**From:** Green, Kimberly  
**Sent:** Tuesday, April 21, 2015 3:57 PM  
**To:** Louie, Richard (rlouie@entergy.com)  
**Subject:** NRC's Draft ACRS Slides  
**Attachments:** IP ACRS SubCommittee 4-23 Briefing 04-22-15.pdf

**Advisory Committee on Reactor Safeguards  
License Renewal Subcommittee  
Indian Point Nuclear Generating Units 2 and 3  
Status Briefing  
April 23, 2015**

Division of License Renewal  
Office of Nuclear Reactor Regulation

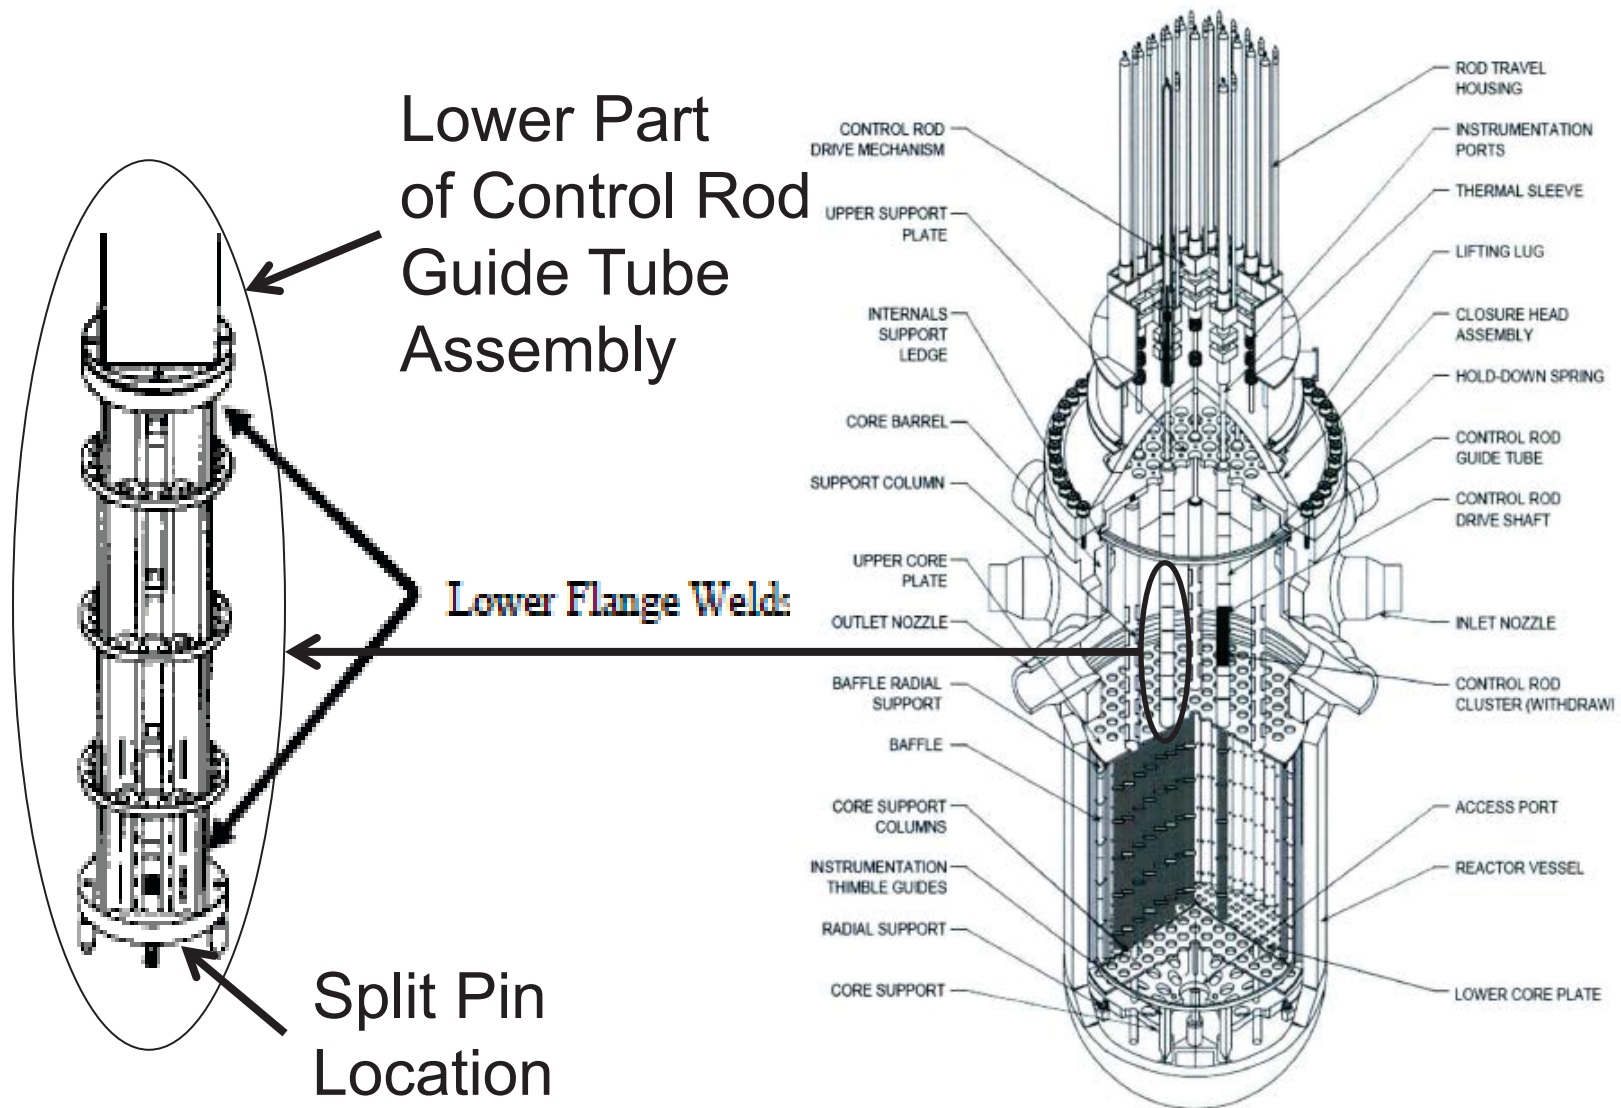
- **A/LAI 2**
  - Recommends applicants ensure that all RVI components within scope of LR are covered by generic components in MRP-191. If not, modify plant-specific program to address the components not covered.
- **Applicant Evaluation**
  - Determined all components
    - Have an equivalent generic component, or
    - Have an equivalent generic component, but different material
  - Plant-specific screening and FMECA for components with different materials – no differences in aging management
- **Staff Finding**
  - Applicant adequately evaluated differences in material, thus applicant adequately addressed A/LAI 2.

# Hold-Down Spring

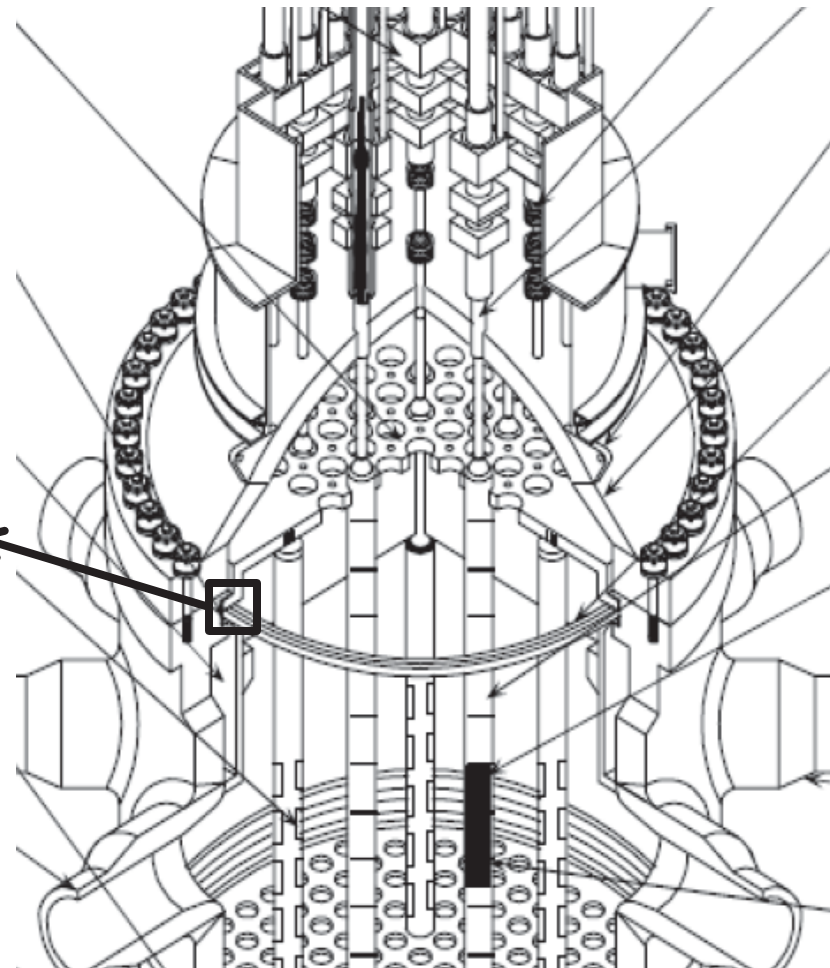
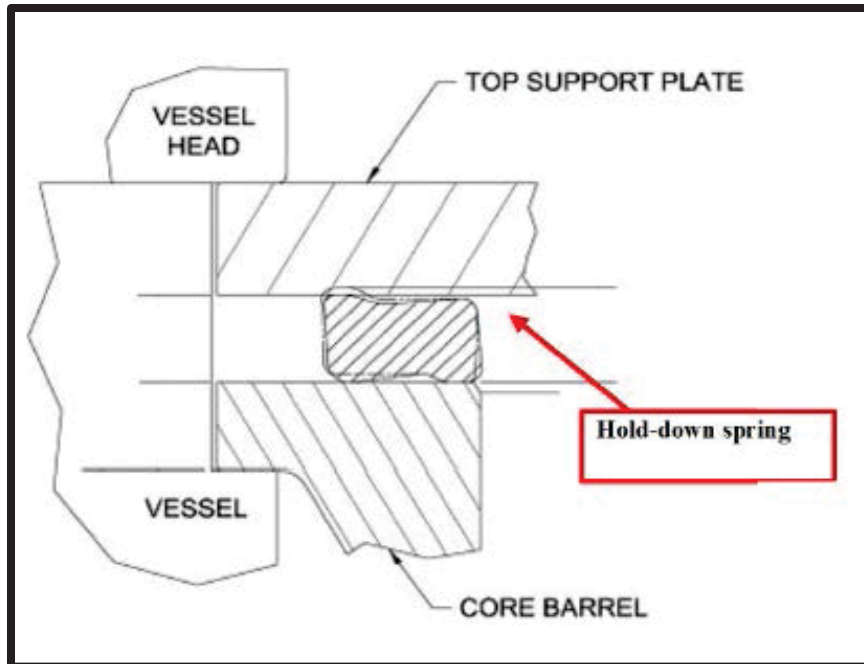
- **A/LAI 5**
  - Recommends licensees identify plant-specific acceptance criteria to be used when performing physical measurements
- **Applicant Evaluation**
  - Applicable to IP hold-down springs
  - Applicant explained how measurements evaluated
    - Linear interpolation between initial and 60-year minimum height to determine acceptable height at first measurement
    - If spring height unacceptable, a follow-up measurement will be performed, or spring replaced
- **Staff Finding**
  - Applicant clarified how acceptable spring height is determined
  - Staff also performed audit of detailed spring height calculation
  - Applicant adequately addressed A/LAI 5

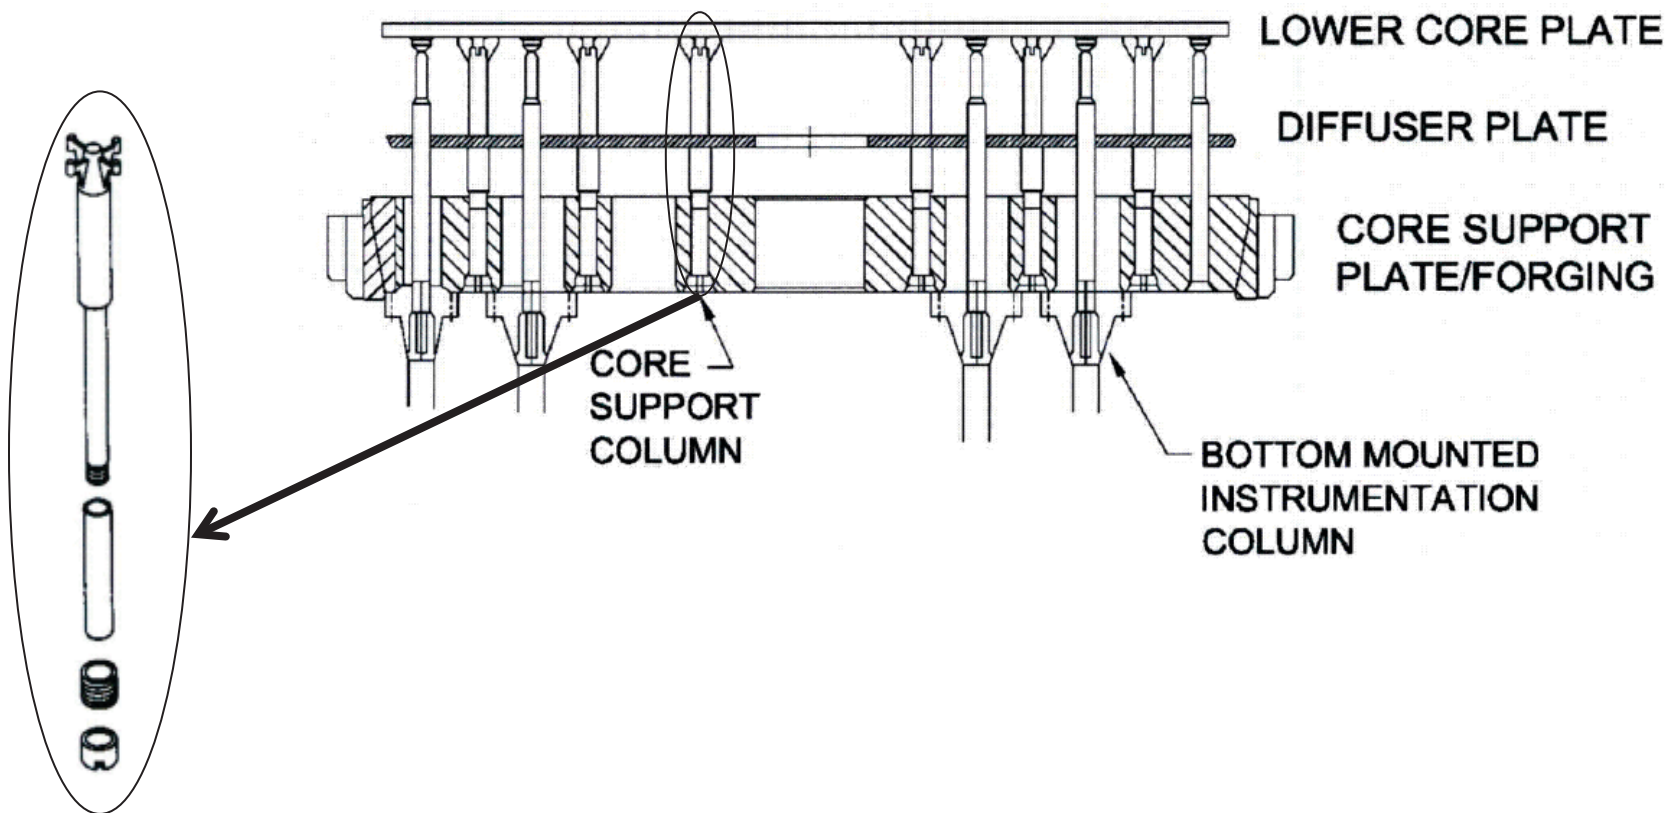
- **A/LAI 7**
  - Licensees must demonstrate functionality of CASS components through end of life considering loss of fracture toughness due to thermal embrittlement (TE ) and irradiation embrittlement (IE)
- **Applicant Evaluation**
  - Applicable to lower support column caps at IP
  - Initially made Commitment 47 to provide detailed analysis prior to PEO
  - In response to staff RAIs, the applicant:
    - Performed screening for column caps – TE screened out
    - Showed pre-existing flaws in column caps unlikely
    - Showed service-induced cracking of column caps unlikely
    - Provided link to an alternate lead component for IASCC and IE (core barrel lower girth weld)

- Applicant provided sufficient information to provide reasonable assurance of functionality of the column caps through PEO because:
  - Screened out TE, therefore only IE applicable, column caps thus equivalent to wrought stainless steel
  - Showed pre-service and in-service flaws very unlikely
  - Provided a link to a primary component that is a good predictor for IASCC and IE
- Applicant adequately addressed A/LAI 7
- Staff agreed with deletion of Commitment 47
